Access Compliance Report

Public Rights-of-Way

Intersection ID: 12629	Main Street: E_6TH_ST	Cross Street: N_DAVIDSON_ST	Location: W
ADA ID: 424ABC258A90	Ramp Type: PerpDiag	Initial Pass/Fail: Fail	Overall Compliance: No
Severity Score: 22.5			
Codes/Mitigation Info/Possible Solution		Field Measurements/Component Compliance

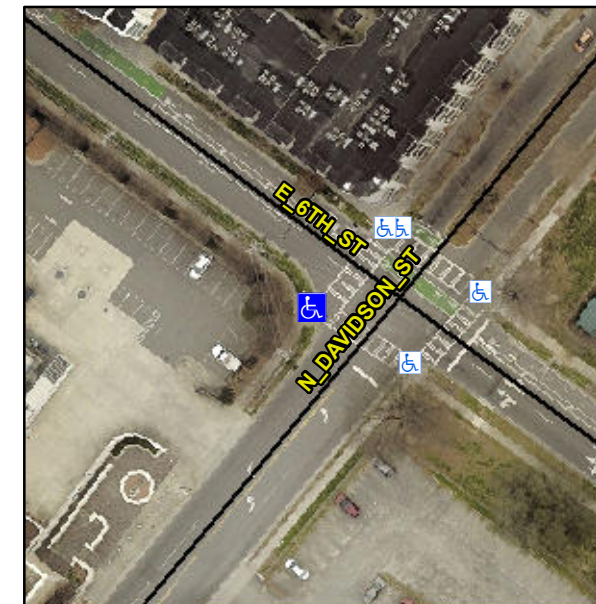
Not Found, R304.5.1, R304.2.2

Compliance	Description	Data	Compliance	Description	Data
N/A	Ramp Length (in)	78.0	No	Ramp Slope (%)	8.5
No	Ramp Width (in)	36.0	Yes	Ramp XSlope (%)	3.3
N/A	Flare Type LT	N/A	N/A	Flare Type RT	N/A
N/A	Flare Slope LT (%)	N/A	N/A	Flare Slope RT (%)	N/A
N/A	Flare Traversable LT?	N/A	N/A	Flare Traversable RT?	N/A
N/A	Landing Length (in)	N/A	N/A	DWS Provided?	N/A
N/A	Landing Width (in)	N/A	N/A	DWS Contrast?	N/A
N/A	Landing Slope (%)	N/A	N/A	DWS Length (in)	N/A
N/A	Landing X Slope (%)	N/A	N/A	DWS Full Width?	N/A
N/A	Landing Curb? (Y/N)	N/A	N/A	DWS Offset (in)	N/A
N/A	Shared Landing?	N/A			
N/A	Gutter Ponding?	Yes	N/A	Gutter Slope (%)	N/A
N/A	Gutter Lip Ht (in)	N/A	N/A	Gutter X Slope (%)	N/A
N/A	Painted X Walk1?	Yes	N/A	Painted X Walk2?	Yes
	X Walk 1 Direction	To SE		X Walk 2 Direction	To NE
N/A	X Walk 1 Width (in)	109.0	N/A	X Walk 2 Width (in)	107.5
	X Walk 1 Slope (%)	1.3		X Walk 2 Slope (%)	2.5
	X Walk 1 X Slope (%)	2.6		X Walk 2 X Slope (%)	1.0

Remove & Replace Curb Ramp With Two New Directional Ramps or Equivalent.
